Proposed Revisions to a Standard Plans Index

Index Number: 700-101

Typical Sections for Placement of Single and Multi-Column Signs

Add retroreflective strip to static WWD sign column, Case X

CASE X

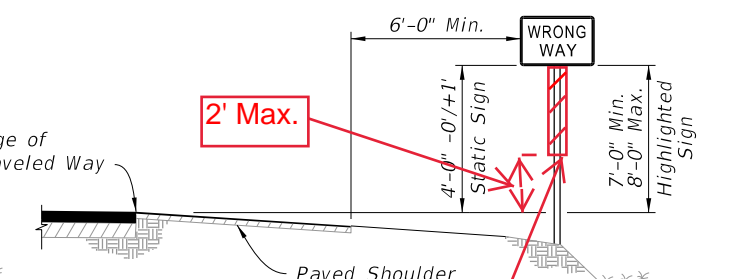
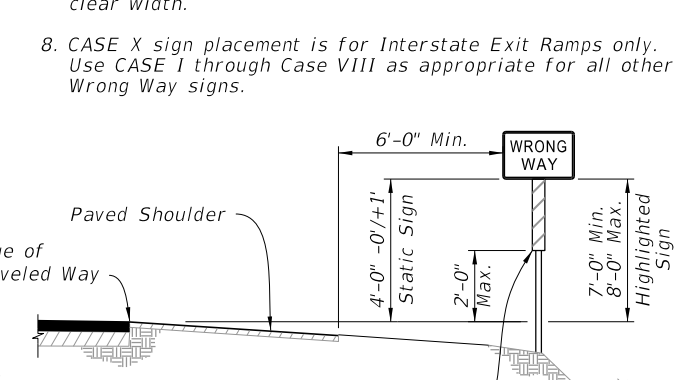
FDM 230.4 states to place retroreflective strip on static WWD sign column. The MUTCD Section 2A-21 "it shall be placed for the full length of the support from the sign to within 2 feet above the edge of the roadway..." An update to Standard Specification 700 is required to clarify the use of the retroreflective strip.

Install Retroreflective Strip in accordance with Specification 700 (Static Signs Only)

Install Retroreflective Strip in Accordance with Specification 700 (Static Signs Only)
